Service Bulletin

DATE: OCTOBER 1991

REF: JD 08/91

FIG 1

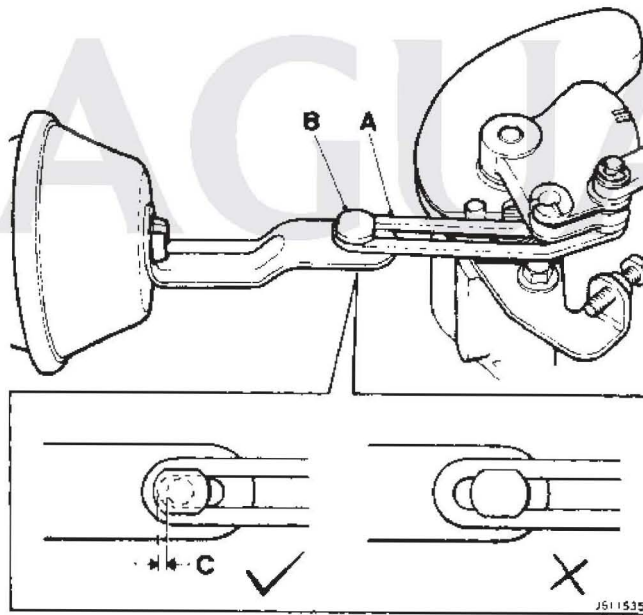
Should customer complaints be received of an increase in the cruise control response time and a degree of hunting of the set speed, the cruise control actuator linkage adjustment should be checked in accordance with the following procedure, before taking any further action.

Dealers should ensure that the clearance between the end of the actuator to throttle link slot (A Fig 1) and the shoulder bolt (B Fig 1) is 0.5mm to 1mm (C Fig 1).

Fig. 1

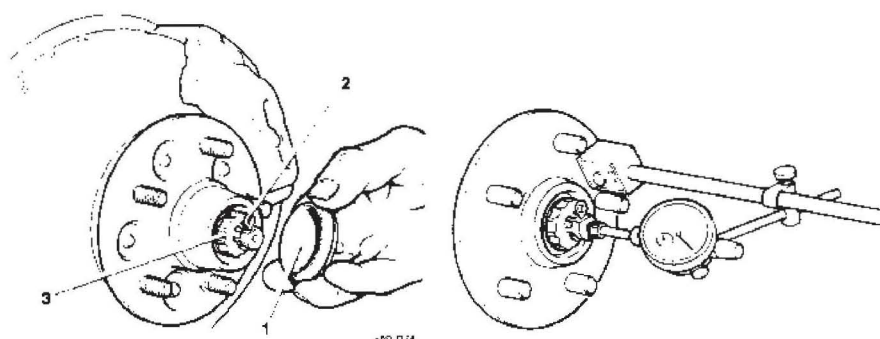
The following instructions supersede all previous instructions provided in service manuals. Manuals will be updated at the next reprint.

Front hub end float on the above models should be set between 0,0254 to 0,0762mm (0.001 to 0.003in). To achieve this in service use the following method:

Adjust the nut, as necessary, to give a reading of 0,0508mm + / - 0,0254mm (0.002in + / - 0.001in).

FIG 1

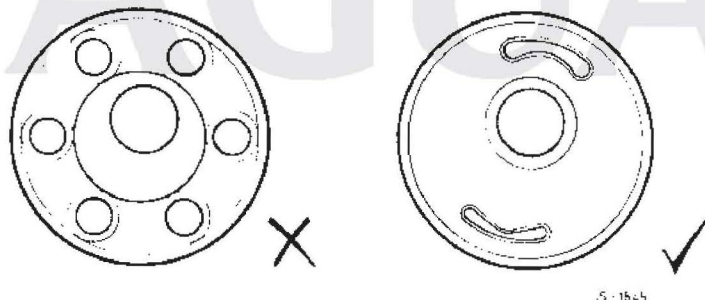
Note: The bushes originally used were termed as 'six-shooter' bushes. These have now been redesigned / replaced by the 'smiley-faced' bushes currently being used, see Fig. 1 for identification.

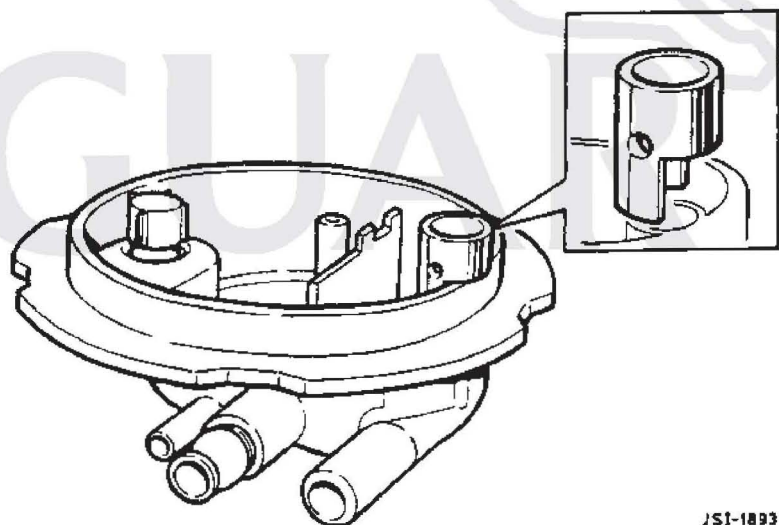
ADVICE TO CUSTOMER : A revised pattern of fuel filler neck assembly may be fitted, which will allow the tank to be filled efficiently to its maximum capacity.

On Pre-Facelift vehicles up to and including VIN 179736 it is only necessary to fit a revised pattern of fuel filler neck and associated seals and gaiter.

On Facelift vehicles, commencing at VIN 179737, it is necessary to fit a breather tube extension in addition to the revised pattern of fuel filler neck and associated seals and gaiter. This involves removal and refitting of the fuel tank, and replacement of additional seals.

Assemble the filler flap to the revised pattern of filler neck, retaining the flap by driving in the new roll pin supplied.

Refit the filler neck to the vehicle, using a new "O" ring at the neck-to-tank joint, and a new gaiter between the filler neck and tank.
